PROPOSED DRAFT GLOBAL TECHNICAL REGULATION (GTR)  
on  
PEDESTRIAN PROTECTION.

This document is a working document circulated for discussion and comments. It is only submitted with the intention to facilitate discussion by the GRSP Informal Group.

GLOBAL TECHNICAL REGULATION NO. Y

Figure 13a: windscreen rear reference line

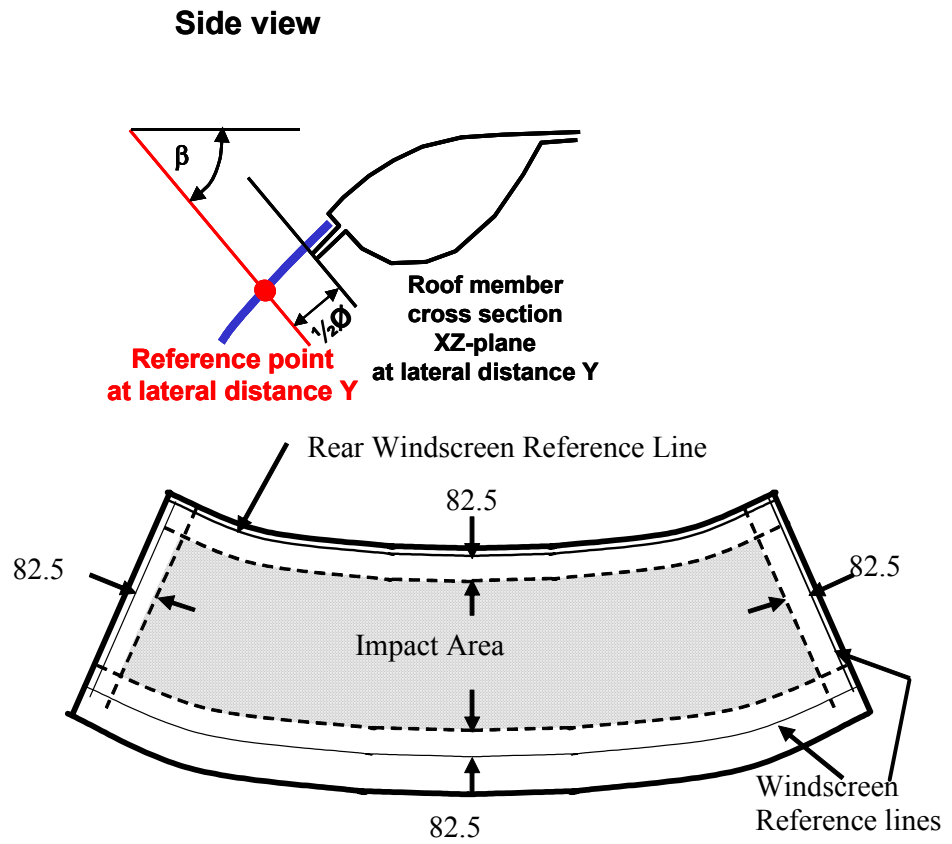
**TO BE WORDED**, see Figure 13a.  
*OICA comment: preliminary agreed on 6. GTR meeting.*  
[EU Comment: This definition and those of 3.34 and 3.35 indeed require more discussion and agreement.](#)

EU Comment: This diagram requires more discussion and agreement.

Figure 13b: windscreen side reference line

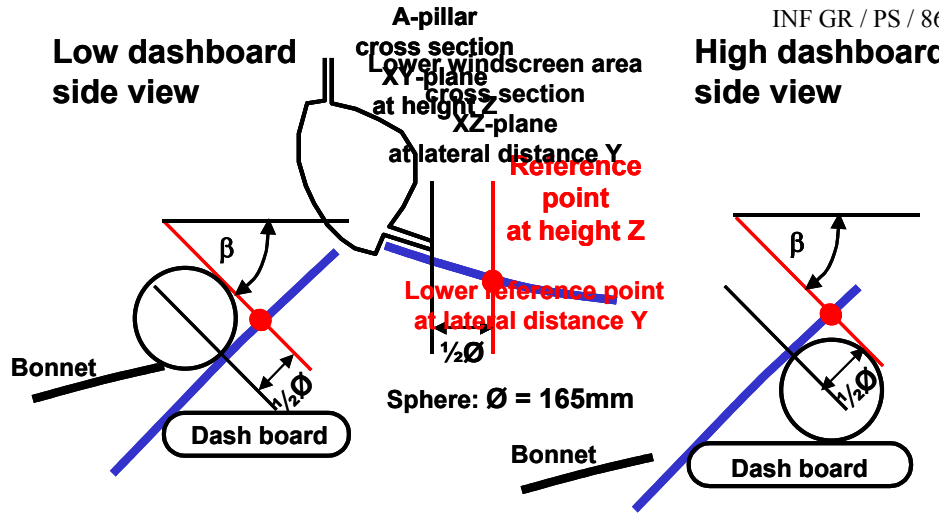
**TO BE WORDED**, see Figure 13b.  
*OICA comment: preliminary agreed on 6. GTR meeting.*  
[EU Comment: This definition and those of 3.23 and 3.35 indeed require more discussion and agreement.](#)

[EU Comment: This diagram requires more discussion and agreement.](#)
